## 2280 DPU HARDWARE

**WANG****ECO****ECO NO. 36643**

PART NO. 210-7422  
 DWG NO. 7422  
 MODEL NO. 2280  
 CLASS I (II) III

DESCRIPTION  
 2200 SMD ECC/Device Interface  
 PEP # PEP# H0133A  
 TYPE  HARDWARE  SOFTWARE

7422 schematic  
part 4

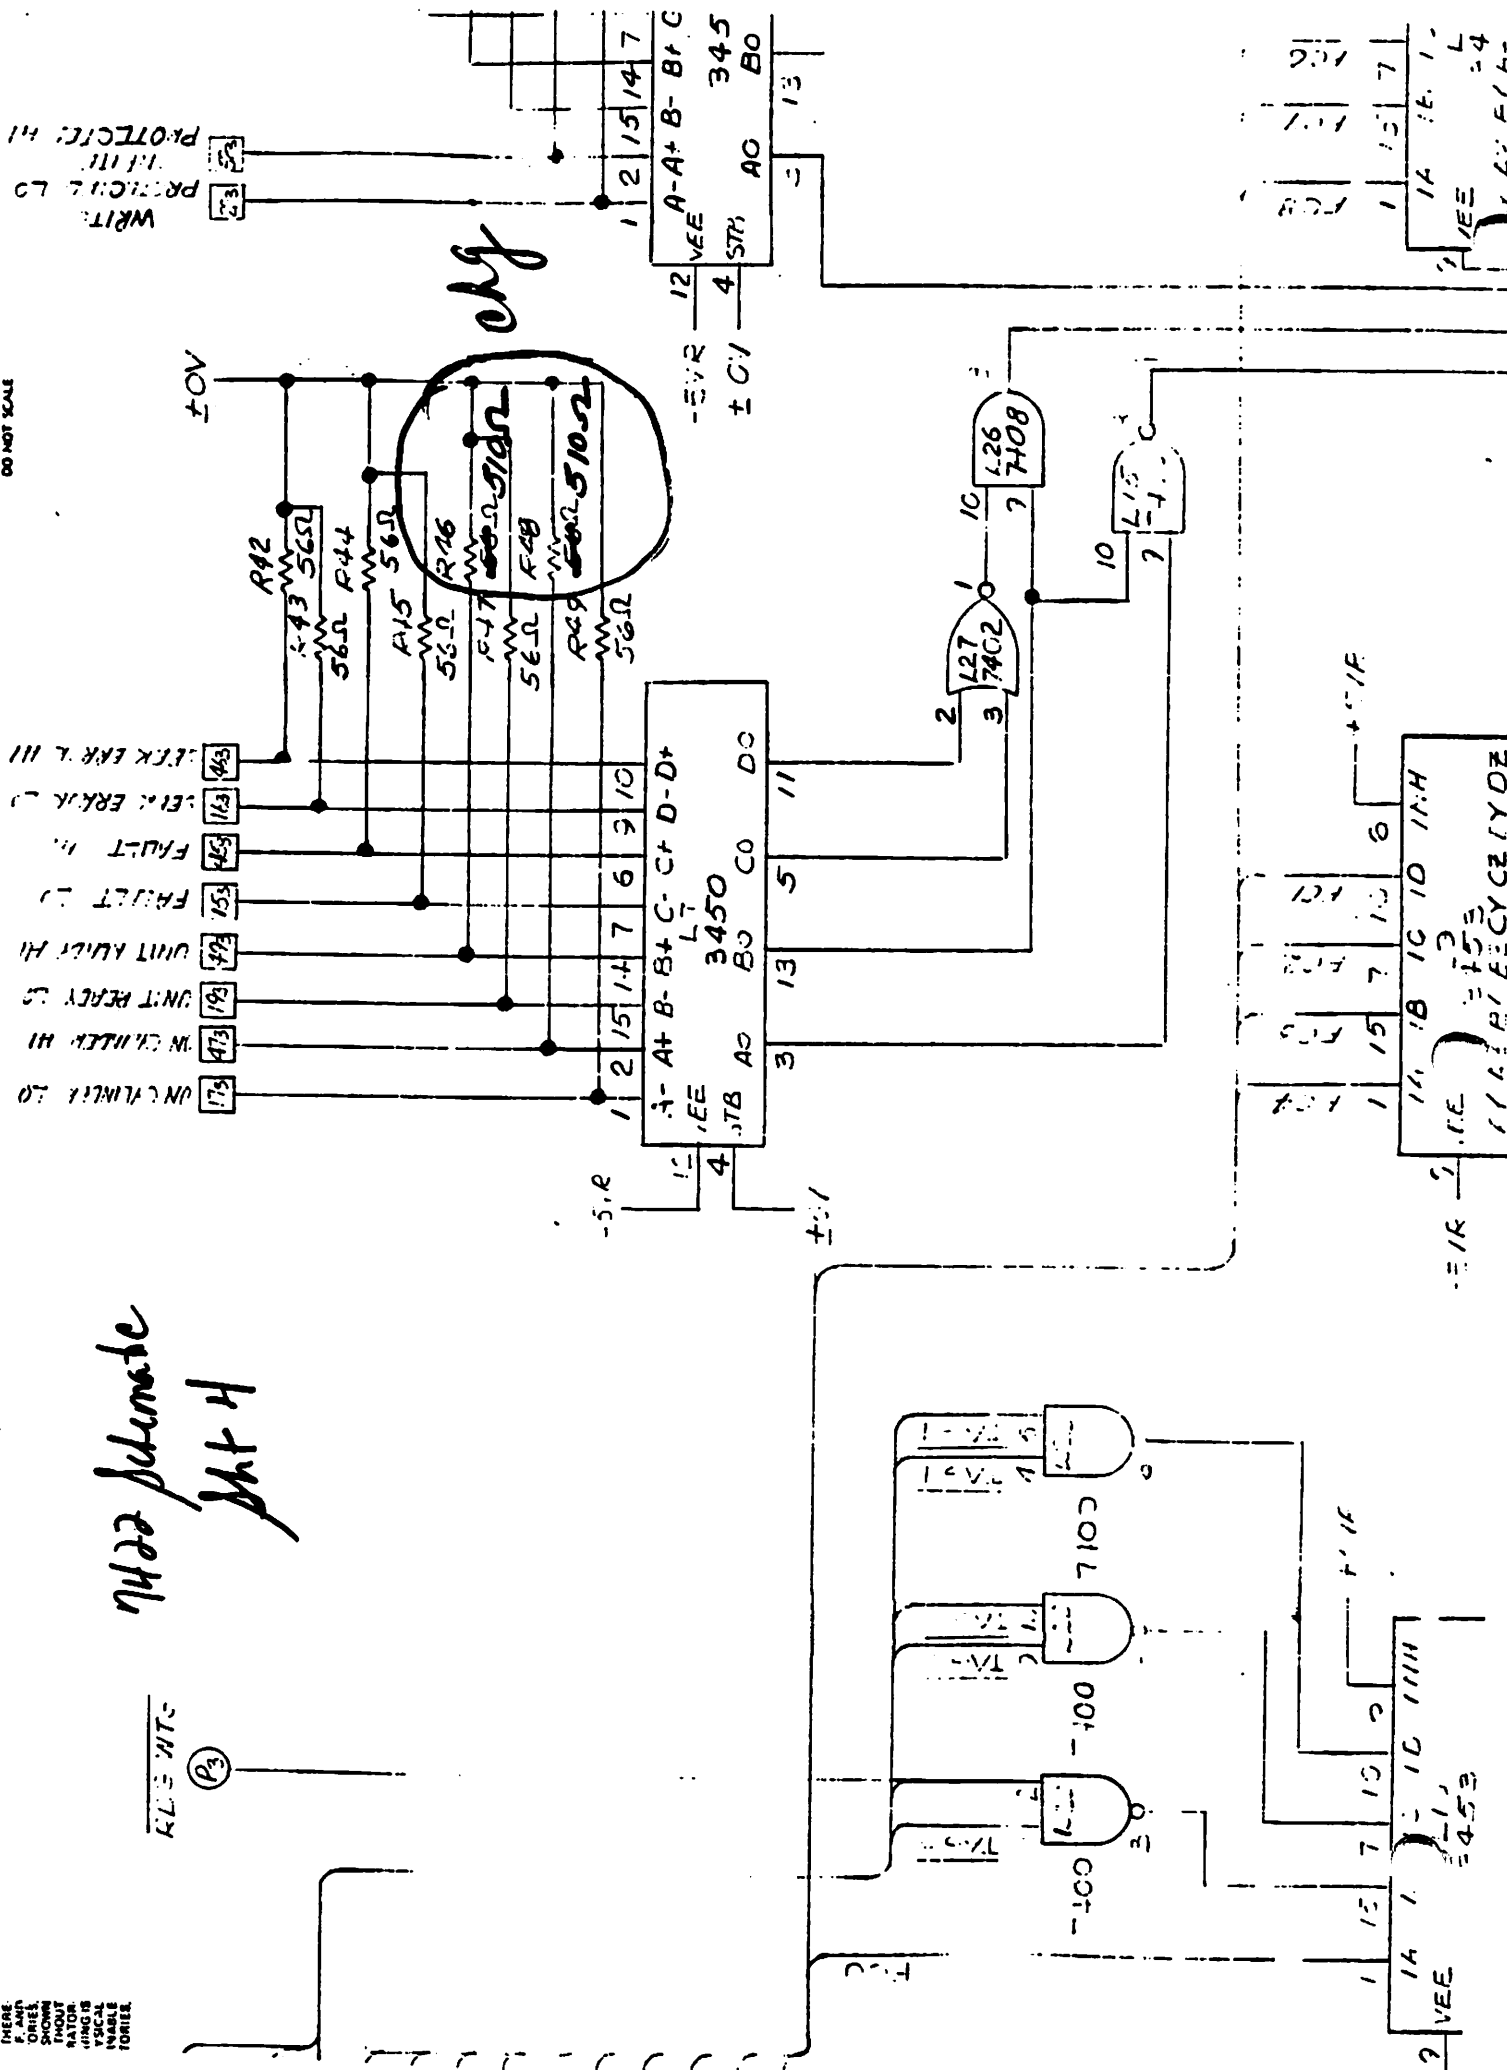
**DESCRIPTION OF CHANGE**  
 Change assembly drawing, schematic and sample board per attached prints.  
 Change BOM 210-7422 as follows:

Note to EDD: Create a 210 History Sheet for this board and create a VS laser parts list for 210-7422. Delete parts list on sheet 6 of 6 of schematics and change parts list as follows:  
 Change R46 and R48 from 56 Ohm Res 1/4 5% (330-1057) to 510 Ohm Res 1/4w 5% (330-2052)

**REASON/SYMPOTM FOR CHANGE**  
 To eliminate noise on the ready line.  
 To correct intermittent hangs and incorrect drive selection.

CHANGE TERMINATION RESISTORS ON 210-7422 BOARD AT LOCATIONS R46 AND R48. RESISTORS WERE CHANGED FROM 56 OHMS TO 510 OHMS.

7422-R6

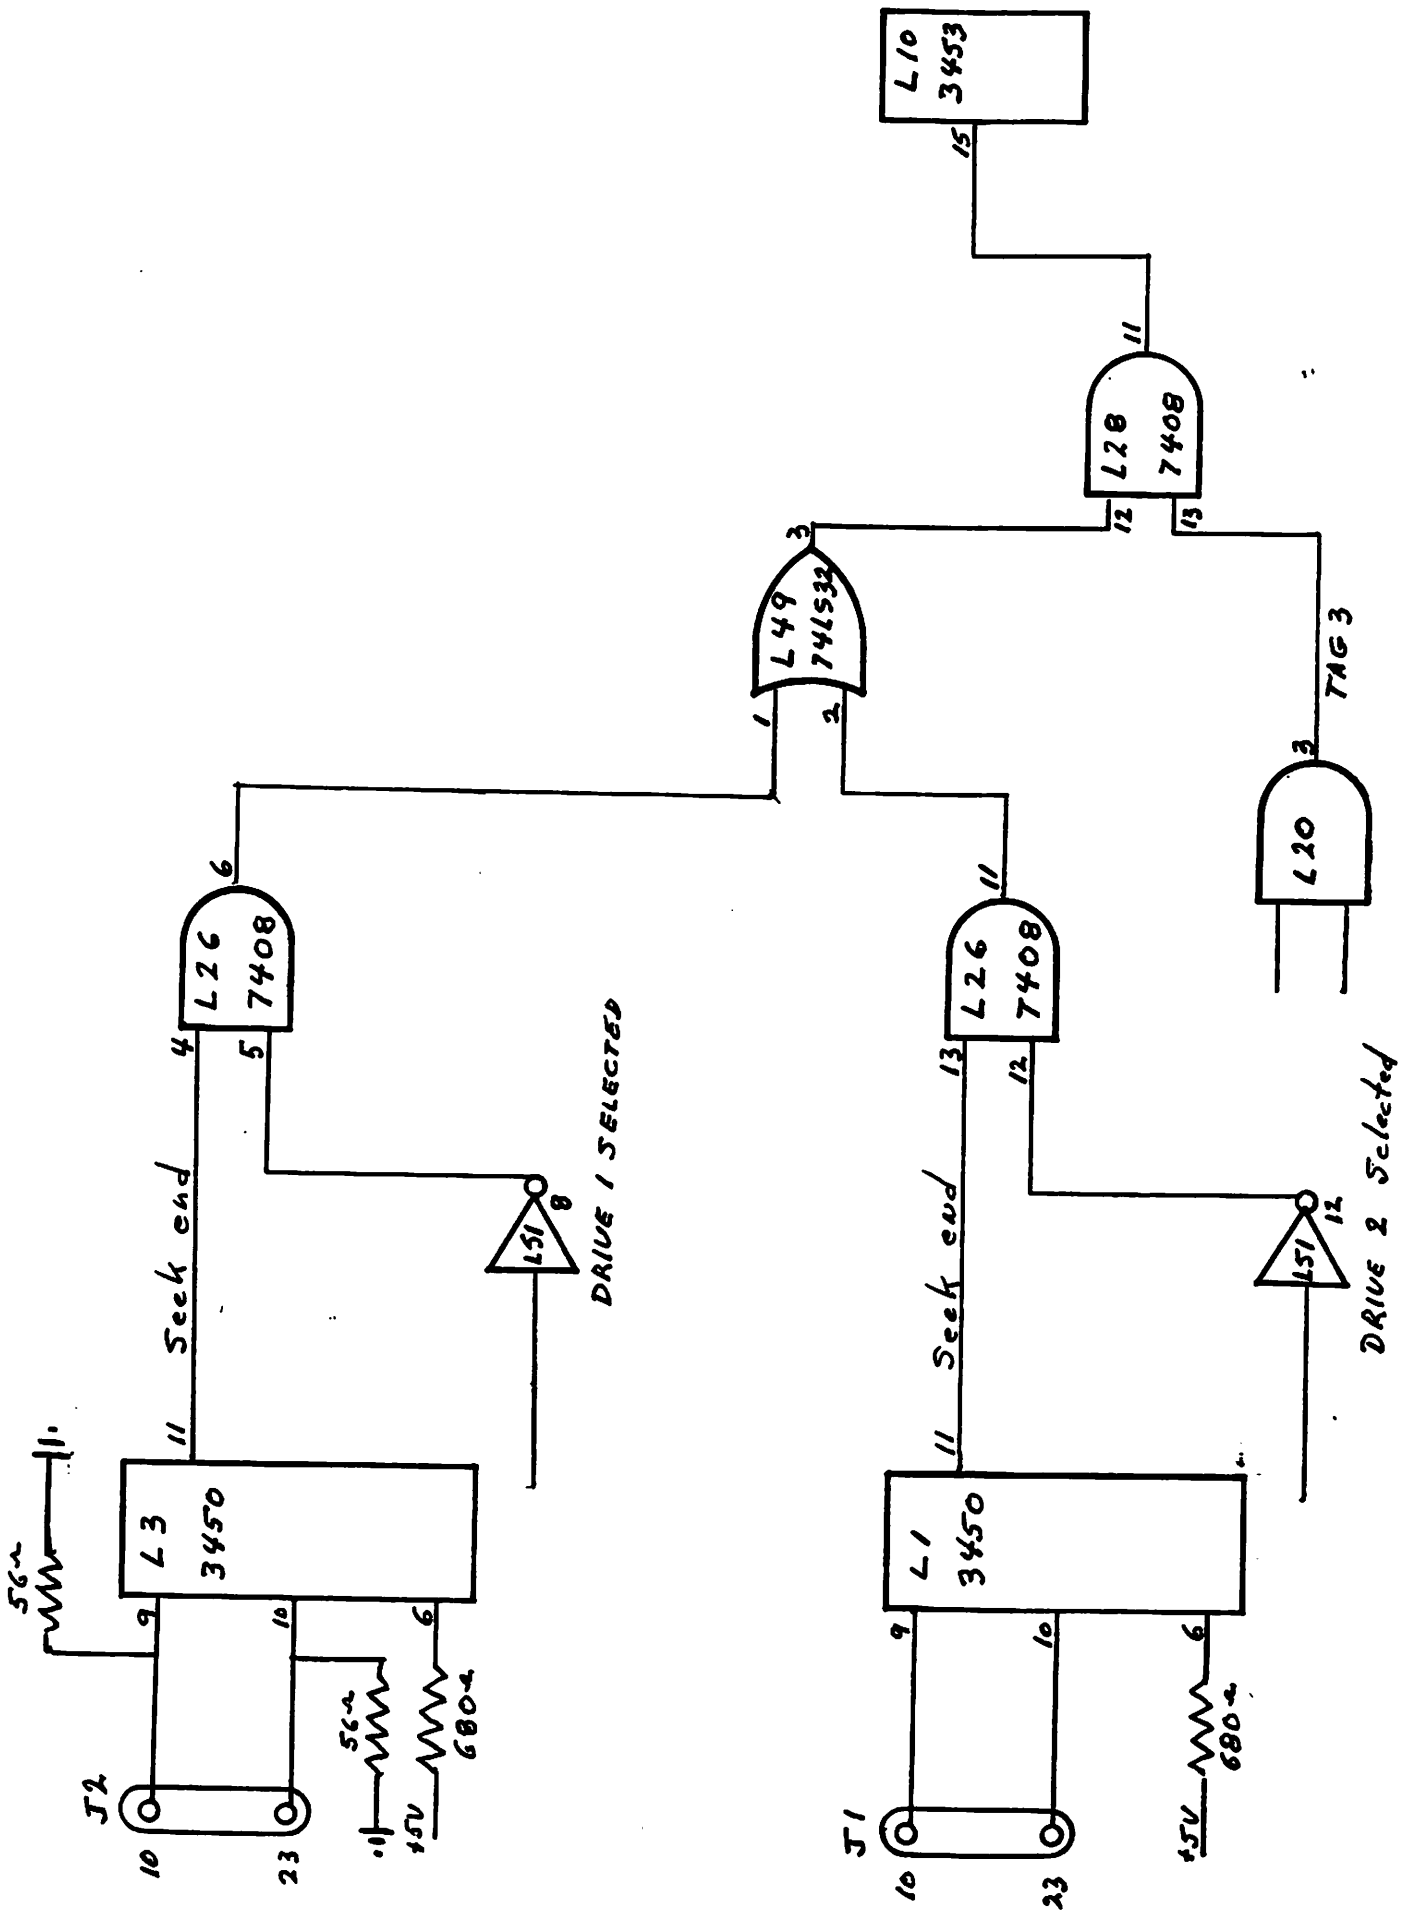
Change R-46 + R-48 to 50 ohm Resistors

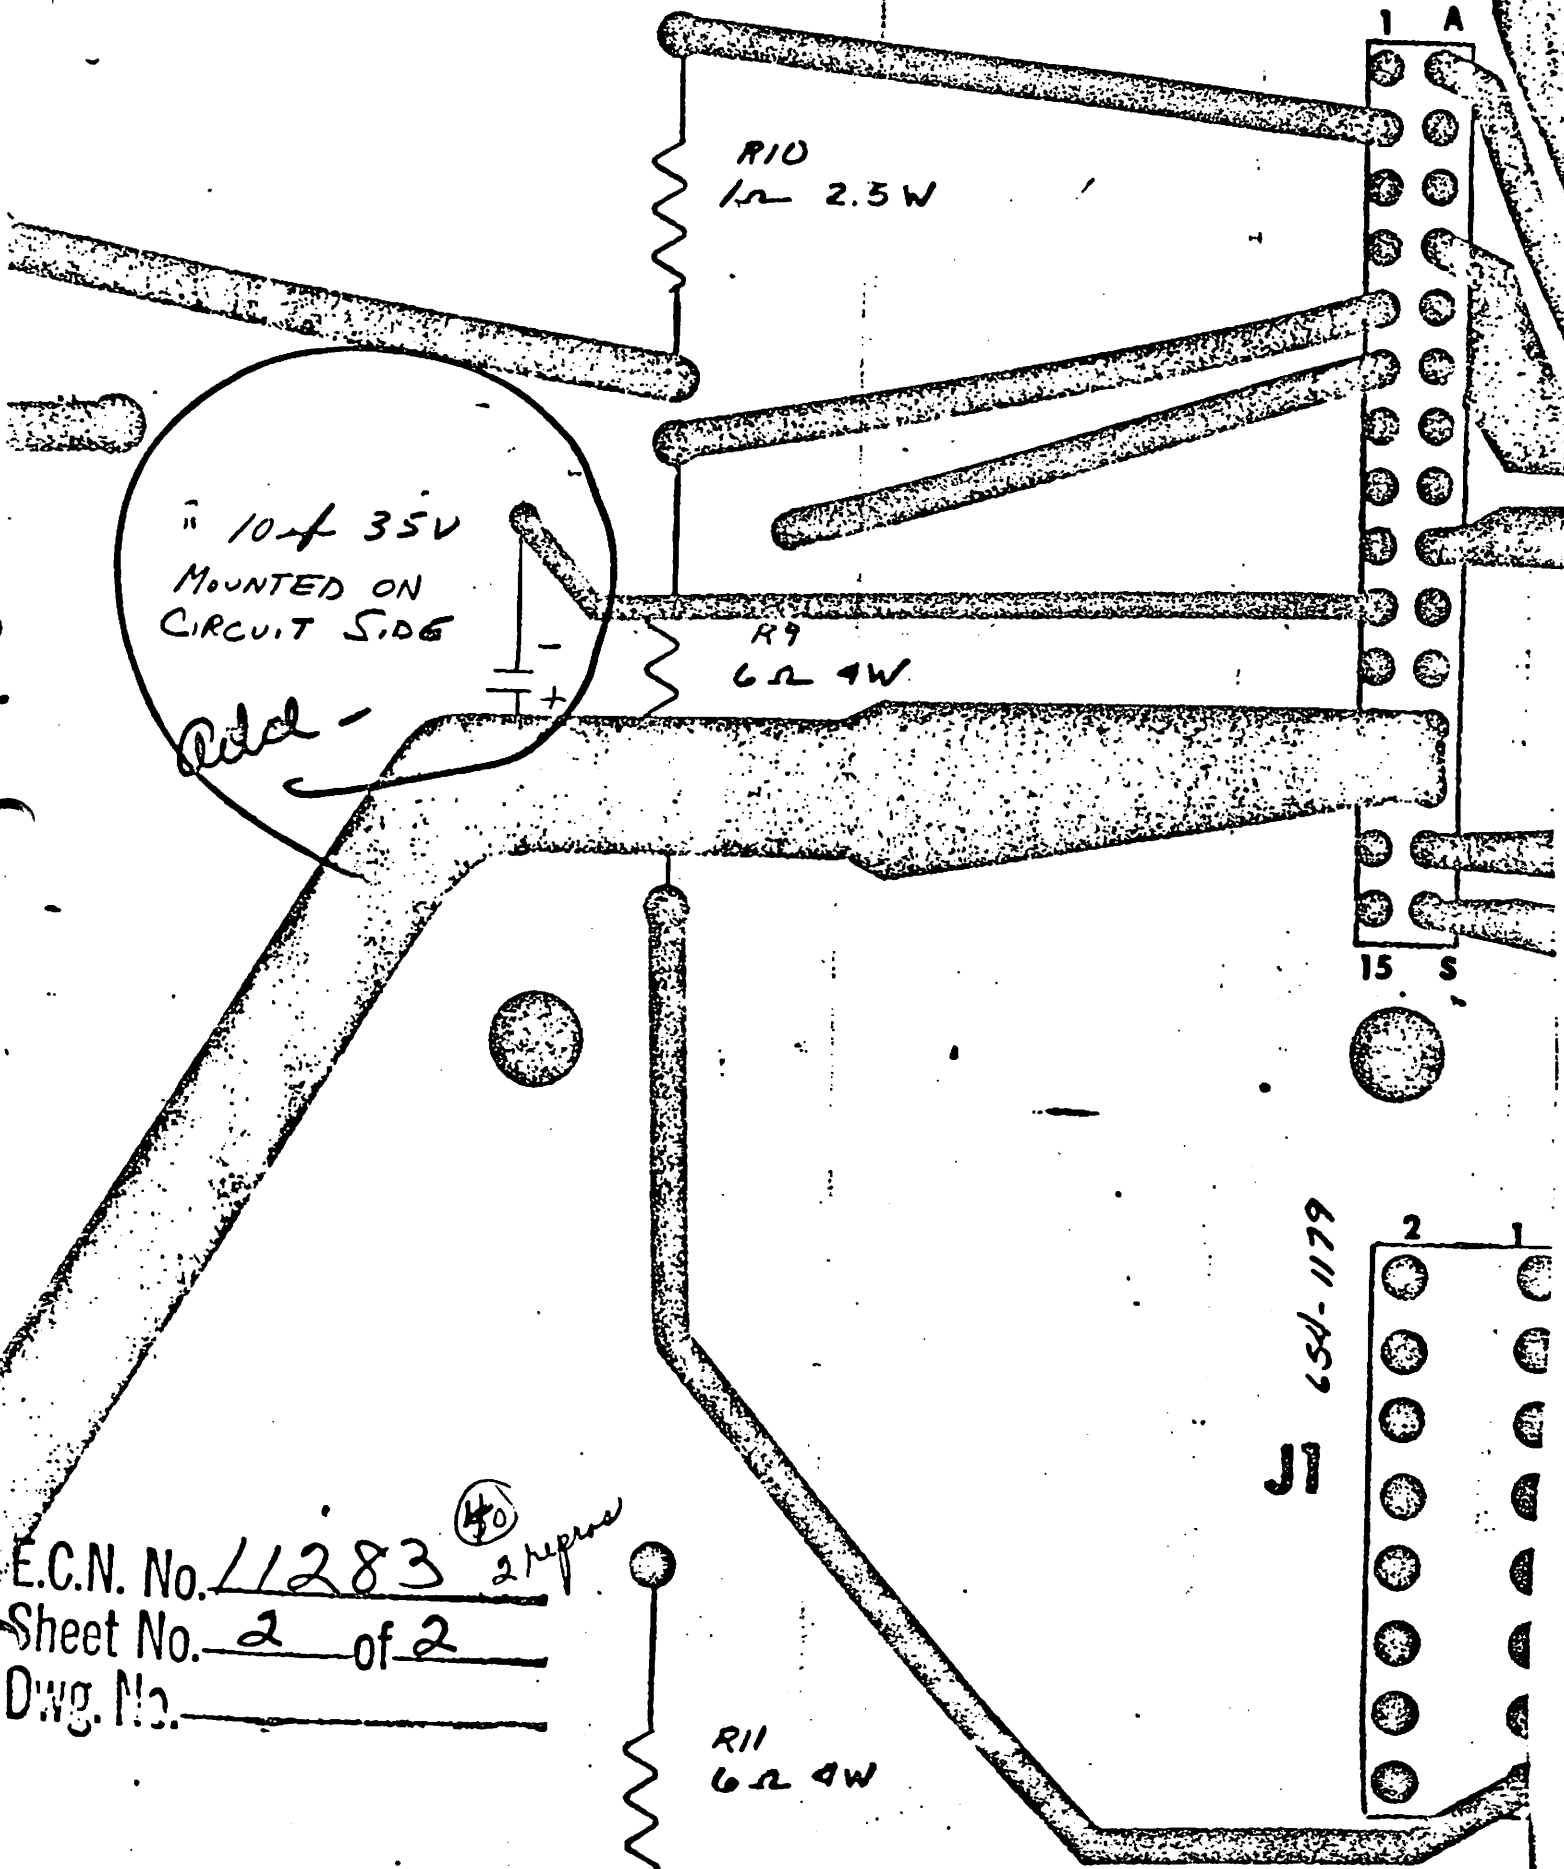
10-35V  
MOUNTED ON  
CIRCUIT SIDE

Add -

E.C.N.  
11587

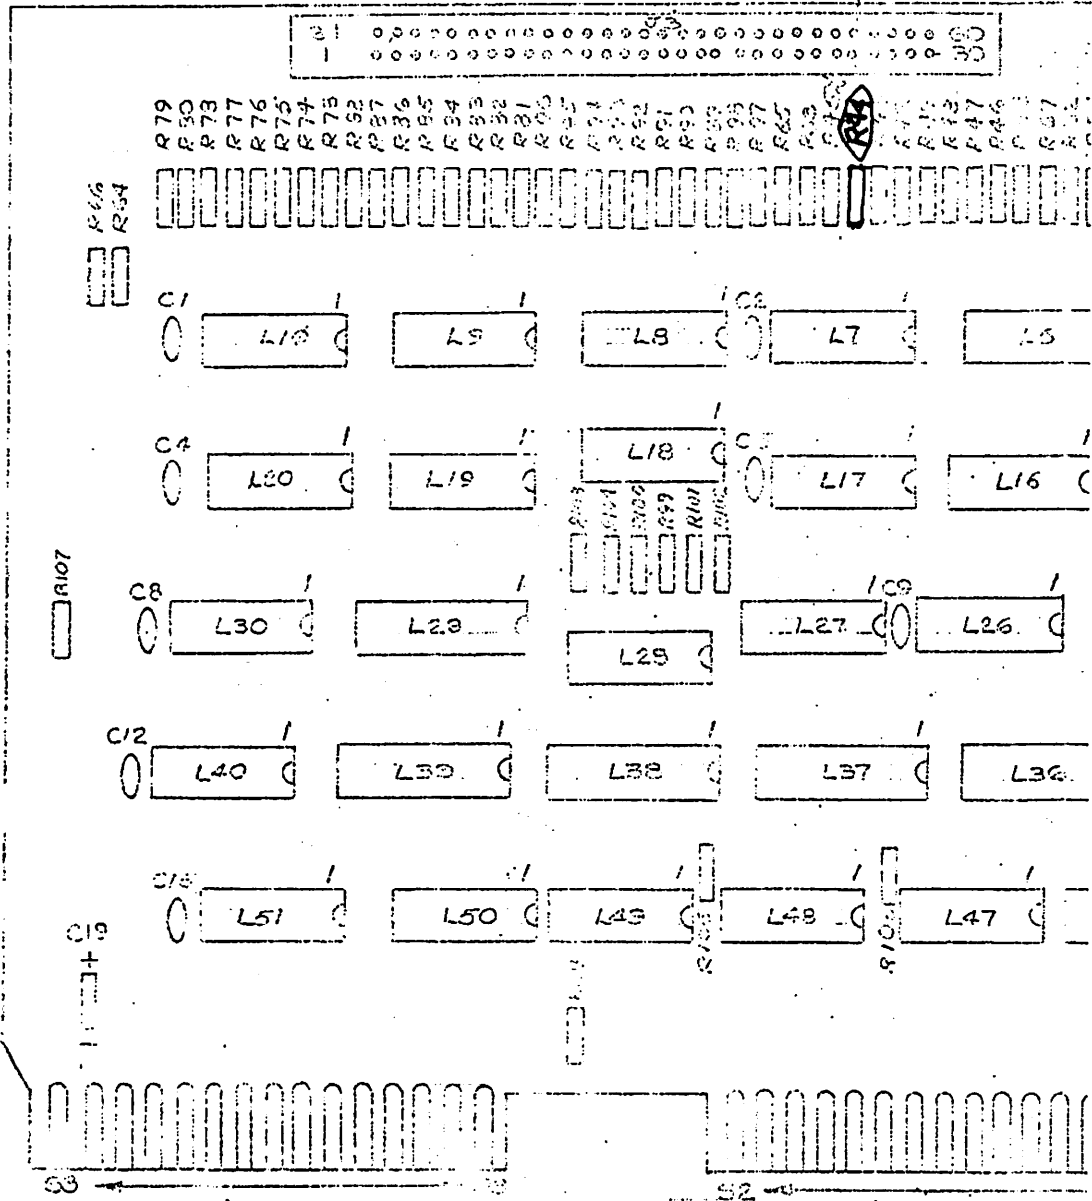
Change R44  
From A 20k res.  
to A 680 ohm res.

1. REMOVE AND REPLACE THE 20K RESISTOR ( WL#330-4021 ) CONNECTED TO PINS 26 AND 56 OF CONNECTOR J3 WITH A 680 OHM RESISTOR ( WL#330-2068 ).
